## Addendum No. 2

Fire Station No. 18

**A/P A2114714**

Cover Letter, Architectural/Structural Changes, Civil Changes, MEP Changes

**A104**

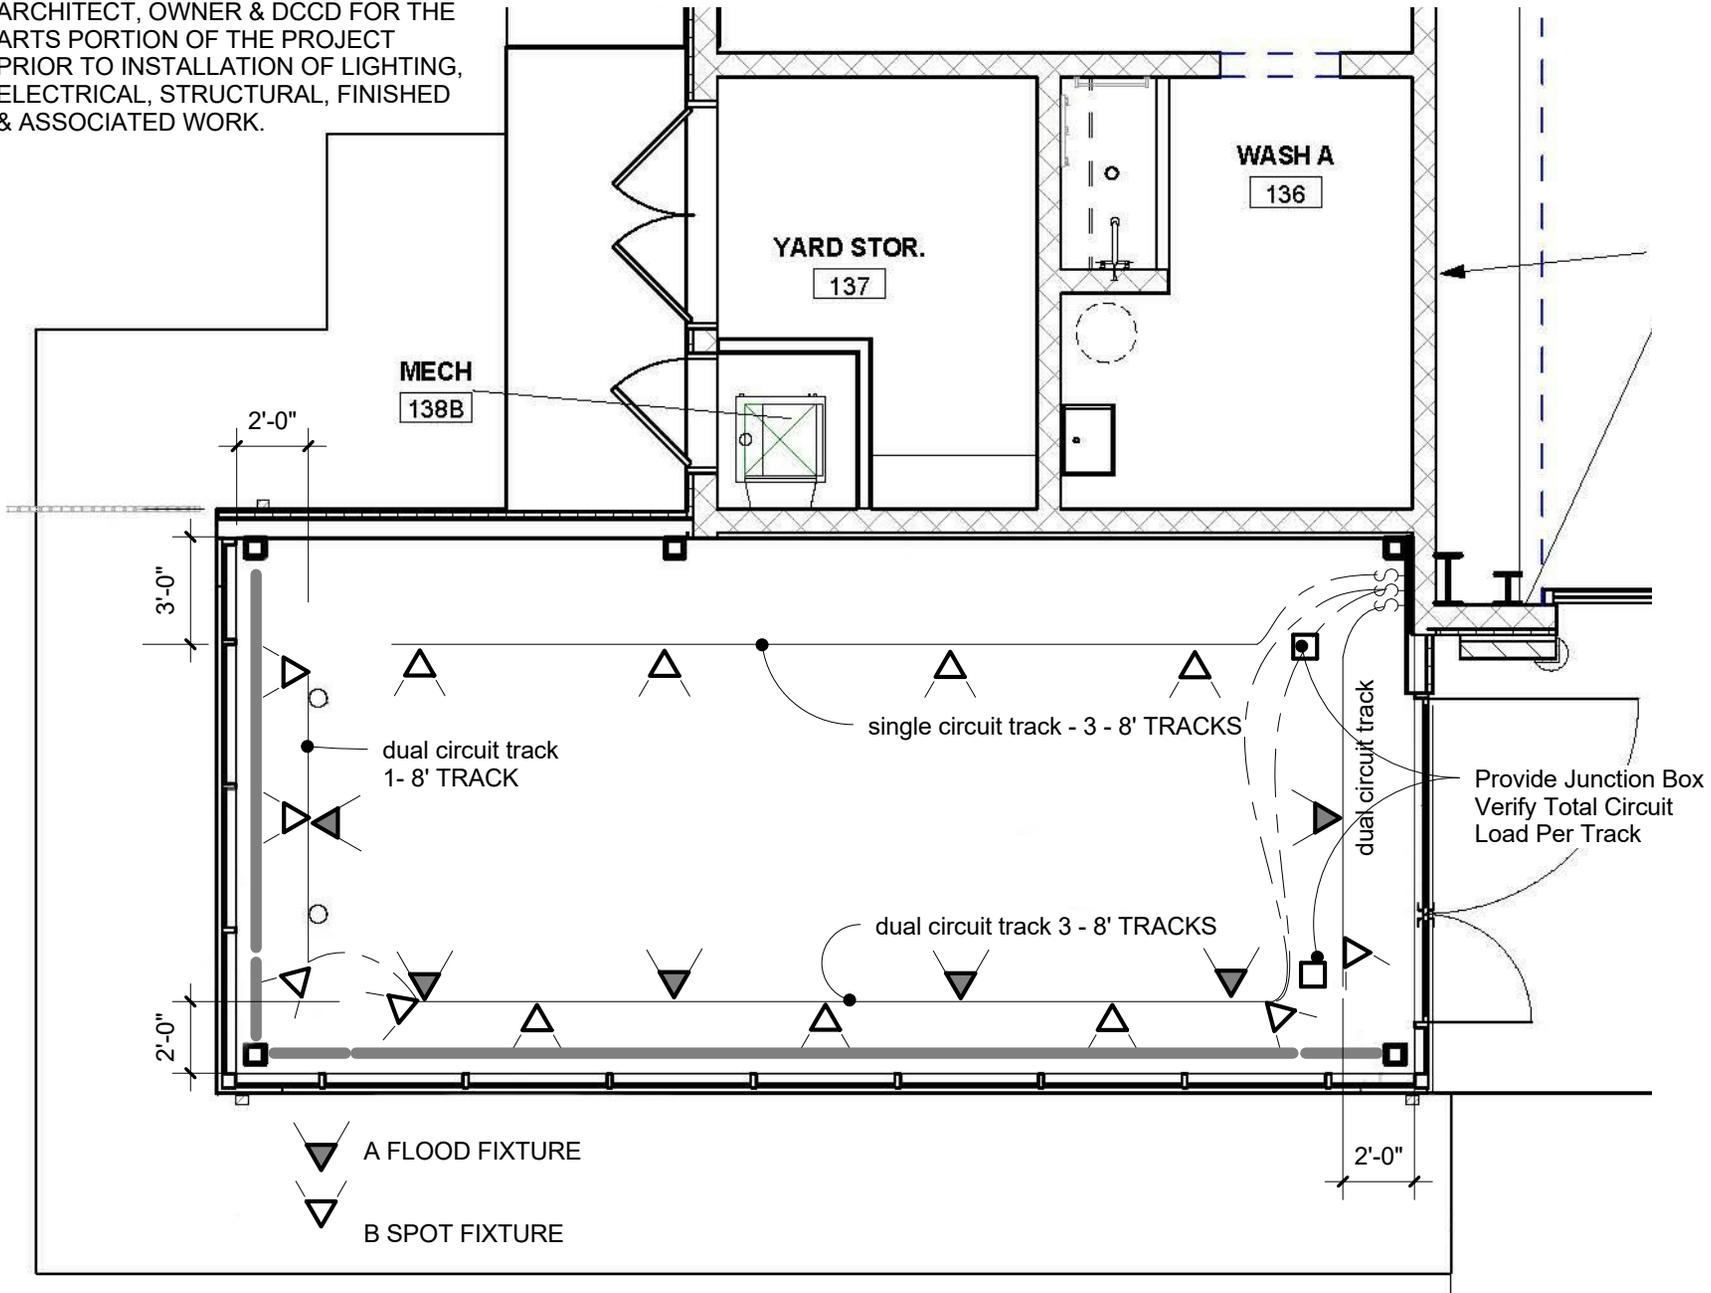
1. Contractor shall arrange a pre-installation meeting with Artist, Architect, Owner (SAFD) and DCCD. **RE: ATTACHED REVISED DRAWING 2/A9.1**
2. Lighting specifications & details from DCCD, Change / Add track lighting and switching from DCCD **RE: ATTACHED REVISED DRAWINGS 1/A4.1, E2.1, E7.1**
3. Add metal fabrication details from DCCD **7/S5.3, 10/S5.3**
4. Change ceiling to gypsum board, add ceiling access panels, change room finishes to coordinate with DCCD **RE: ATTACHED REVISED DRAWINGS 1/A4.1, SCHEDULE A9.1, SPEC. SECTIONS 08 3100**
5. Modify Mechanical vent **RE: ATTACHED REVISED DRAWINGS M2.1, M2.1A**
6. Refer to Artist Drawing for required coordination **RE: ATTACHMENT E – DRAWINGS FROM ARTIST**

CONTRACTOR TO ARRANGE A PRE-INSTALLATION MEETING WITH ARTIST, ARCHITECT, OWNER & DCCD FOR THE ARTS PORTION OF THE PROJECT PRIOR TO INSTALLATION OF LIGHTING, ELECTRICAL, STRUCTURAL, FINISHED & ASSOCIATED WORK.

LIGHTING & CIRCUITS TO BE PROVIDED AND INSTALLED BY CONTRACTOR, COORDINATE PLACEMENT WITH ARTIST.
